## COUNCIL ASSESSMENT REPORT

<b>Panel Reference</b>	<b>PPSSCC-311</b>
<b>DA Number</b>	<b>866/2022/JP</b>
<b>LGA</b>	<b>The Hills Shire Council</b>
<b>Proposed Development</b>	Demolition of Existing Structures and Construction of Four Residential Flat Buildings and Terrace Dwellings comprising a total of 118 units and basement car parking
<b>Street Address</b>	2 – 22 Larool Crescent and 44 – 50 Carramarr Road Castle Hill, Lots 5 – 14 DP 232658 and Lots 17 – 19 DP 237030
<b>Applicant/Owner</b>	Castle Larool Dm Pty Ltd/ Mr KD Y Cao, Mr Z Elkass, Mrs E Elkass, Mr W Liu, Mr J Banicevic, Mrs E L Banicevic, Mrs H J Griffiths, Mr W Z Ye, Ms F Jiang, Mr Z Liu, C & W Pty Ltd, Mr R B Potter, Mrs T M Potter, Mrs S N Flanders, Mrs D M Flanders, Mr N Siafakas, Ms R A Schirripa, Mr A E Farlow, Mrs T M Farlow, Mr G Xiao and Mr N B Kong.
<b>Consultant/s</b>	Mecone – Planner PTW – Architects Site Image – Landscape Architects Newton Fisher Group – Cost Summary Varga Traffic Planning – Traffic and Parking Assessment Australis Tree Management – Arborist PKA Acoustic Consulting – Acoustic Report AED Group – BCA Compliance Report EI Australia – Preliminary Site Investigation and Geotechnical Report ACO

Figure 2 – Submitted Flood Mitigation Works Plan

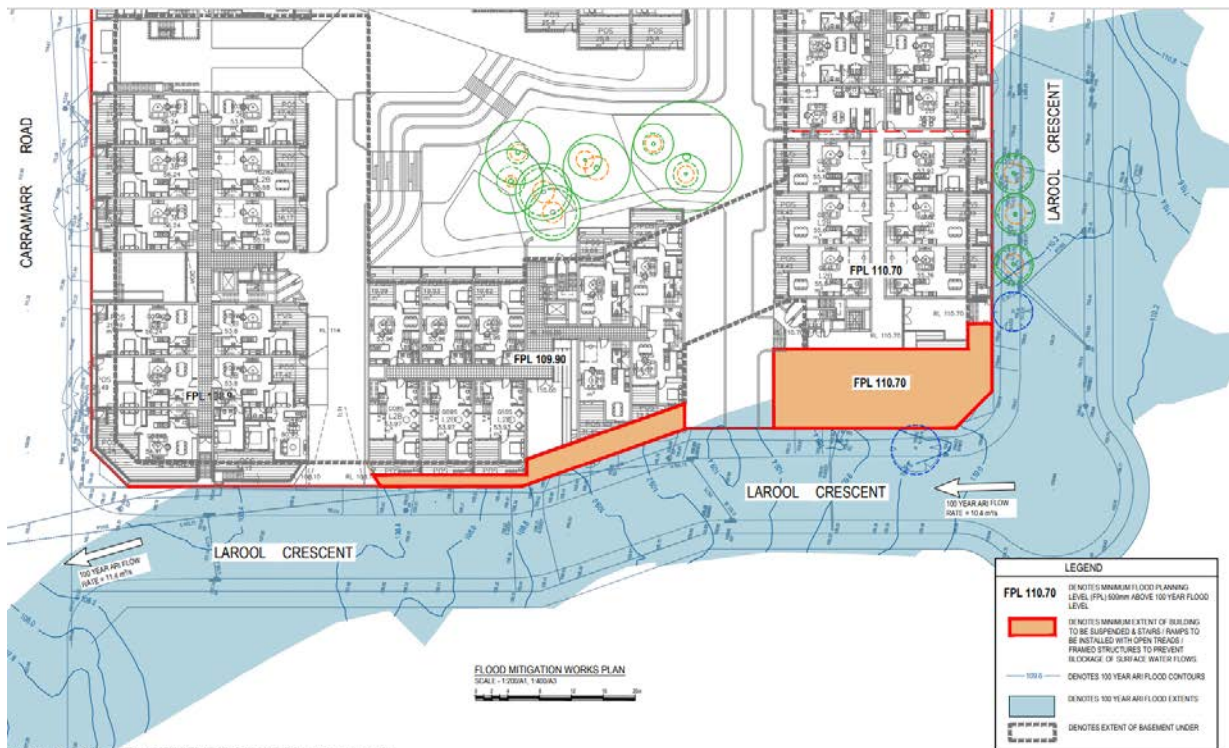
The site is identified as flood prone land as an overland flow path exists along the south-eastern corner of the site. The current plans include this overland flow path through a portion of the eastern building in the south-eastern corner. Refer figure below which reflects the submitted flood extent to date (noting the flood model upon which this plan relates has not been accepted by Council staff).

The Applicant has provided a flood model on 4 November 2022 proposing upsizing of the street drainage on Larool Crescent to mitigate flooding impacts to the development. If the flood no longer extends into this part of the site, the above design will change. However, Council's Waterways and Engineering sections have determined this flood modelling to be insufficient. In this regard, it cannot be concluded that the development will not result in detrimental impacts to the flood function and behaviour on the land.

As above, the current plans include an overland flow path through a portion of the building in the south-eastern corner. If the flood no longer extends into this part of the site, the above design will change. Further, the floor level and driveway crest will need to be set according to the flood planning level which is still unresolved. An updated flood impact assessment is yet to be provided to address the risk associated with the driveway location, which is made better by any reduction in the flood extent. However, the reduction in the flood extent is yet to be quantified and cannot be determined with the information provided to date.

Figure 7: Section of private courtyard within Carramarr Road frontage

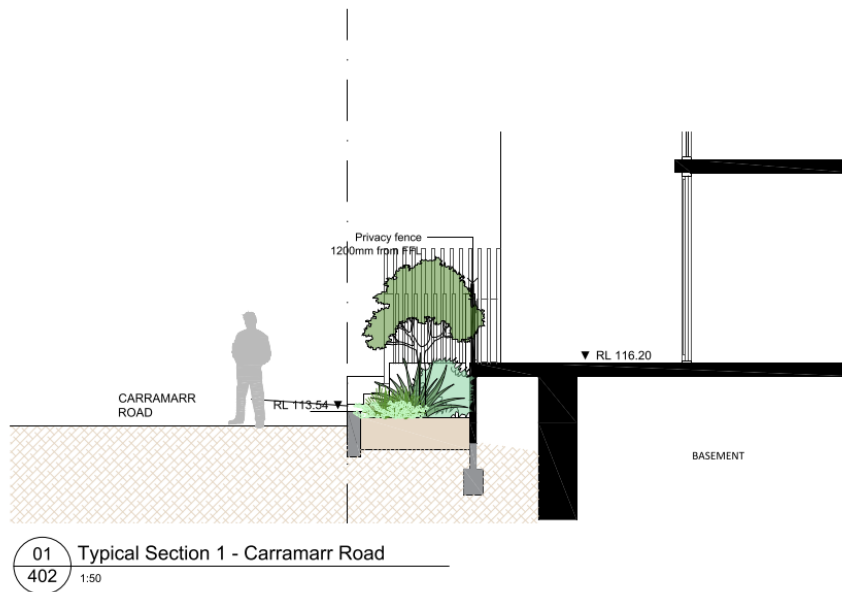
To provide a more suitable visual amenity outcome and respond to the human scale of the streetscape, the proposal has been amended to provide more landscaping at street level to screen the retaining walls. Refer typical section below. This has resulted in a reduced depth to portions of private open space areas.

It is considered that despite the variation, residents of the ground level units would still have reasonable levels of amenity within the front courtyards fronting Carramarr Road, as well as utilise the communal open space are located within the development site.

Figure 8: Diagram from Applicant's original flood report with orange dot indicating location of vehicular access to the development.

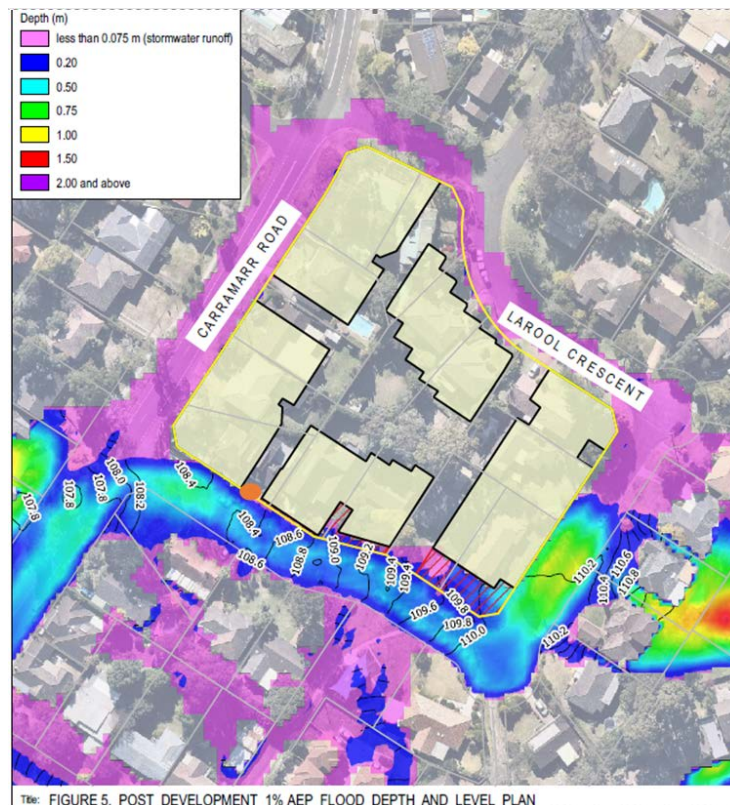
The site specific assessment and submitted engineering reports are insufficient to determine that the above controls have been met. The development proposal results in a residential development located within an existing overland flow path and incorporates habitable and non-habitable flood levels within the floodway area. In particular, the vehicular access to the proposed development is in a high hazard flood area. Refer figure below. The vehicle movements in the floodway could potentially increase the flood impacts on the properties in the locality including on the western side of Carramarr Road and southern side of Larool Crescent.

The flood model upon which the planning levels have been derived have not been accepted by Council staff. In this regard, it cannot be determined that the proposed floor levels and driveway crest are suitable until the flood planning level and extent of flooding is quantified.

Figure 10: Elevation indicating revised indent to eastern building.

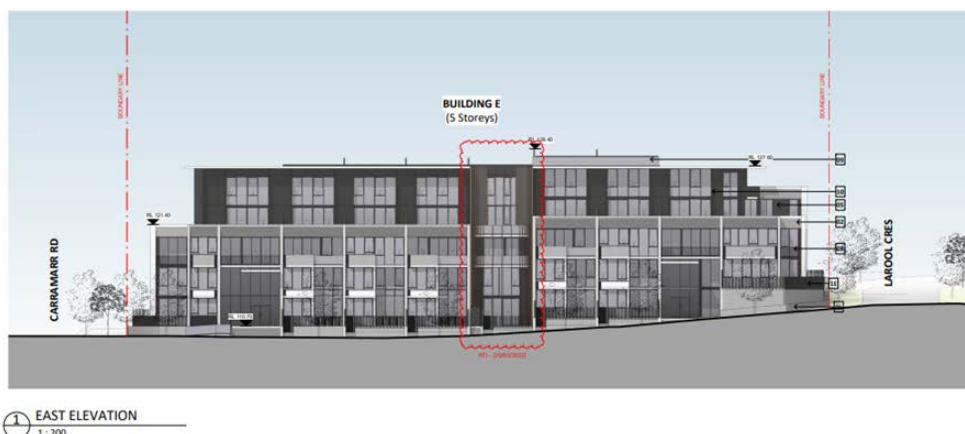
Despite the variation of 3m to the maximum building length, the eastern building has been amended to provide a more defined indentation to distinguish the two facades as highlighted in the below plans, elevation, and above perspective. It is considered that the amended design is well articulated, breaks up the mass of the building into two forms and the use three storey framing elements on the bottom levels juxtaposed with contrasting external finishes and colours provides a positive streetscape outcome and achieves a high-quality architectural design. In this regard, the variation can be supported in this instance.

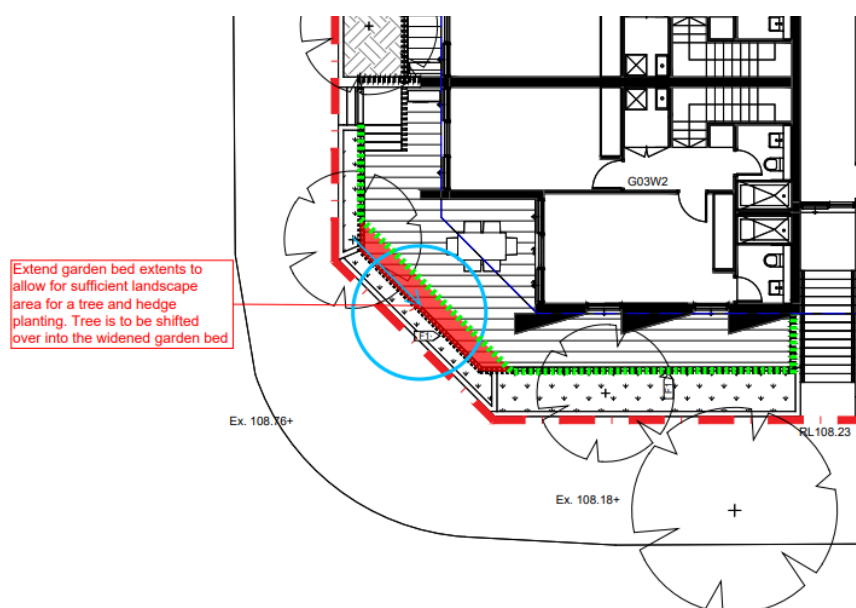
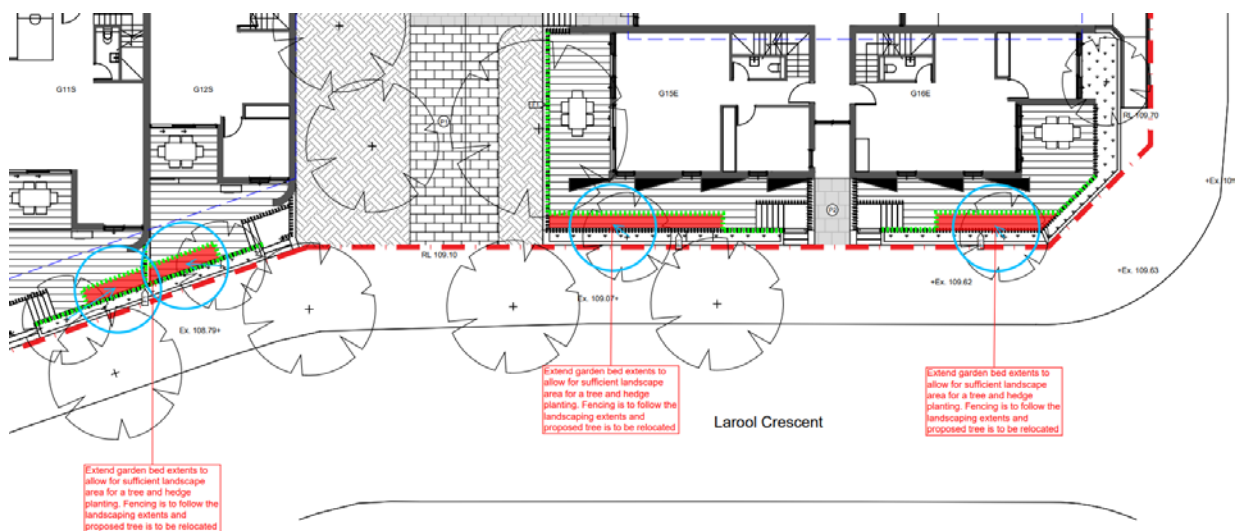
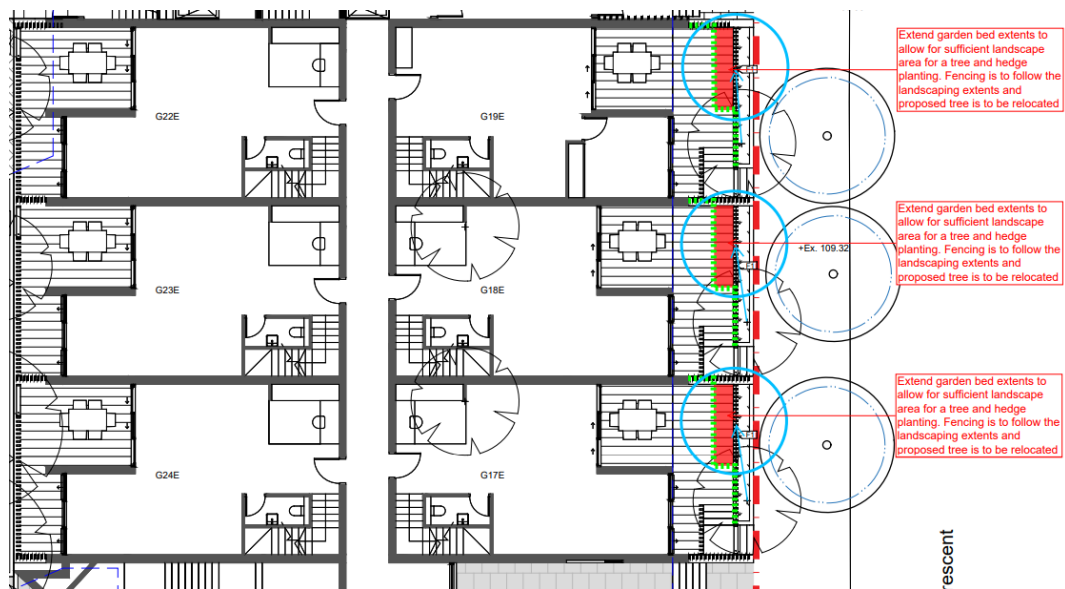
Given the site fronts four streets, a key consideration of the development is the architectural treatment of the buildings at its interface to the streets. The desired future character of the area under the DCP envisages *terrace edge streetscapes characterised by 'tree lined streets with soft landscape treatments within the front setback areas of terraces to soften the interface of the built form with the public realm'*.

The original proposal as lodged included brick retaining walls up to 3m in height abutting the front property boundaries which is inconsistent with this character statement. To respond to concerns raised by Council staff, the application has been amended to include a tiered planter

box arrangement and more landscaping at street level to screen the retaining walls. Whilst this provides some improvement to soften the interface of the built form, further landscaping is required to achieve the objectives of the control and meet the desired future character statement.
